DEPARTMENT OF TRANSPORTATION

[Docket No. FAA-2020-0883; Project Identifier 2019-CE-034-AD]

Airworthiness Directives; Rockwell Collins, Inc. Flight Display System Application

ACTION: Notice of proposed rulemaking (NPRM).

Figure 1 to paragraph (g)(1)(iii); placard location on bezel

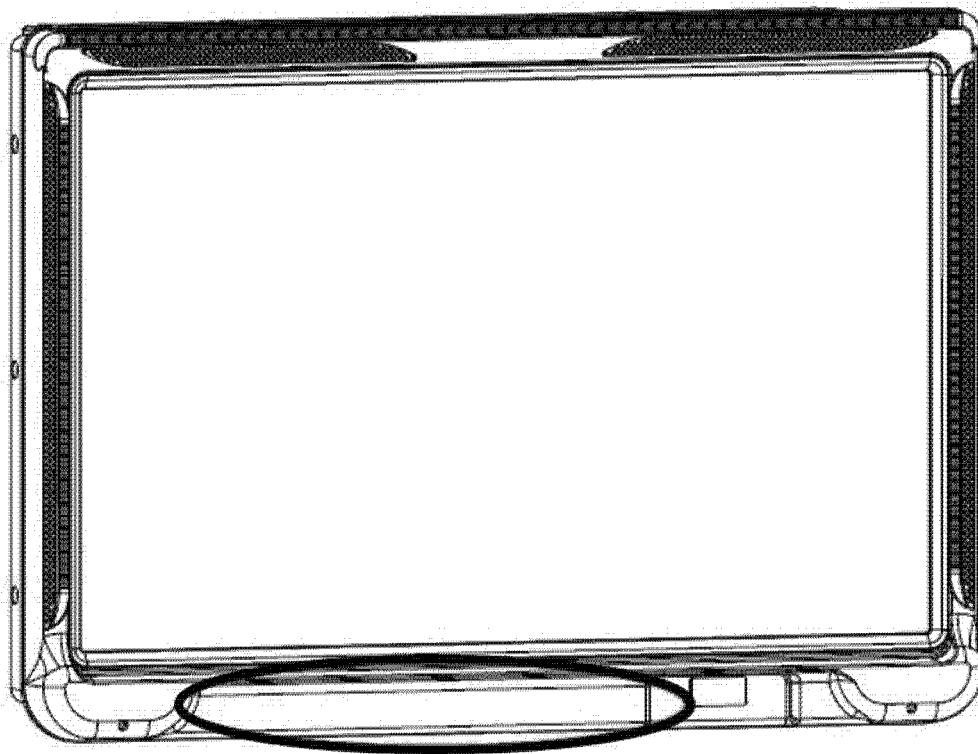
(ii) Fabricate a placard for each aircraft primary flight display, using at least ⅛ inch letters, with the following text: TCAS Flight Ops—TA Only mode (TA/RA mode prohibited).

(iii) Install the placard on the bottom of each aircraft primary flight display bezel in the area depicted in figure 1 to paragraph (g)(1)(iii) of this AD.
